U.S. Department of the Interior BUREAU OF LAND MANAGEMENT Sundry Print Repor

US Well Number: 3002552266 Well Status: Approved Application for **Operator: EARTHSTONE**

Type of Submission: Notice of Intent Type of Action: APD Change

Procedure Description: APD CHANGE SUNDRY TO REVISE WELL NUMBER, POOL/TARGET, LTP, BHL WELL NUMBER FROM: PAKSE 3 SOUTH FED COM 432H TO: PAKSE 3 SOUTH FED COM 113H; POOL/TARGET FROM: (96438) HAT MESA; WOLFCAMP TO: (53560) SALT LAKE; BONE SPRING; LAST TAKE POINT FROM: F-36-20S-32E; 2540 FNL, 2310 FWL TO: F-36-20S-32E; 2538 FNL, 2310 FWL; BOTTOM HOLE LOCATION FROM: F-36-20S-32E; 2630 FNL, 2310 FWL TO: F-36-20S-32E; 2628 FNL, 2310 FWL

WELL LOCATION AND ACREAGE DEDICATION PLAT

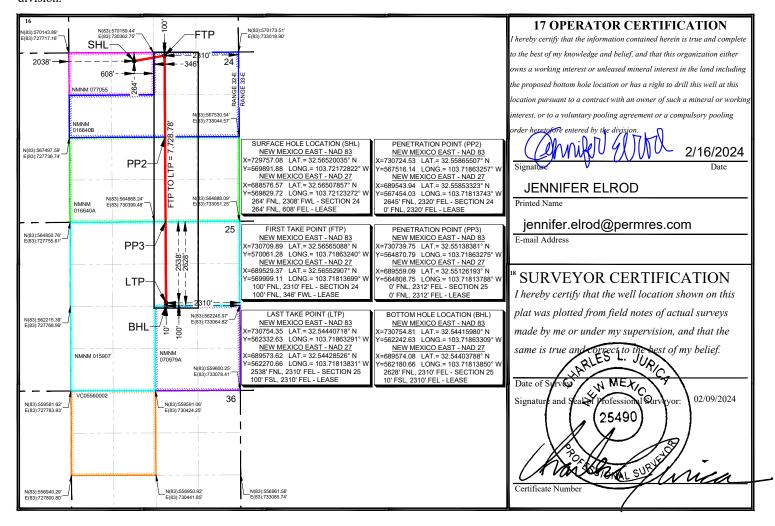
FROM: F-36-20S-32E; 2630 FNL, 2310 FWL TO: F-36-20S-32E; 2628 FNL, 2310 FWL

WELL NUMBER, POOL, LTP, BHL
